802.3ck D3.0 Comment Resolution Clause 163 and 163B

Phil Sun, Credo

List of Comments

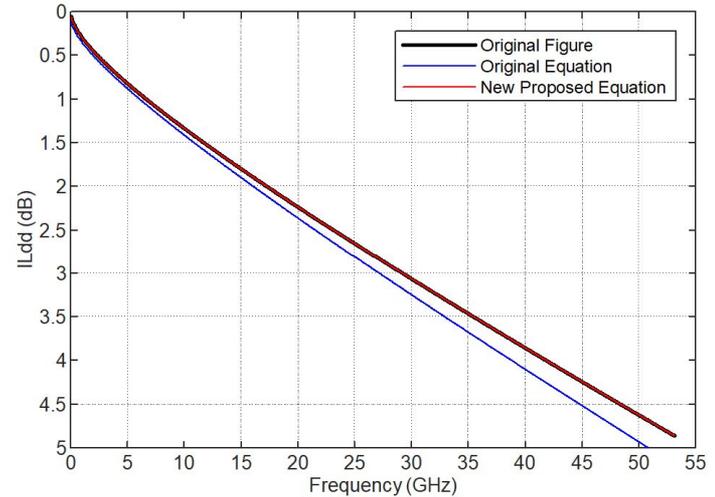
CI **163B** SC **163B.2** P**322** L**31** # **I-223**
Dawe, Piers J G NVIDIA
Comment Type **T** Comment Status **D** Example TF ILdd

Figure 163B-1 doesn't match Equation 163B-1.

I believe the graph is right, and the right coefficients are 0, 0.235616, 0.059147.

PROPOSED ACCEPT IN PRINCIPLE.

Figure 163B-1 is plotted according to the PCB trace model in Clause 163B.2. The following presentation suggested this PCB trace model and pointed out Equation 163B-1 loss is slightly different:

Change the coefficients of equation 163B-1 as suggested.
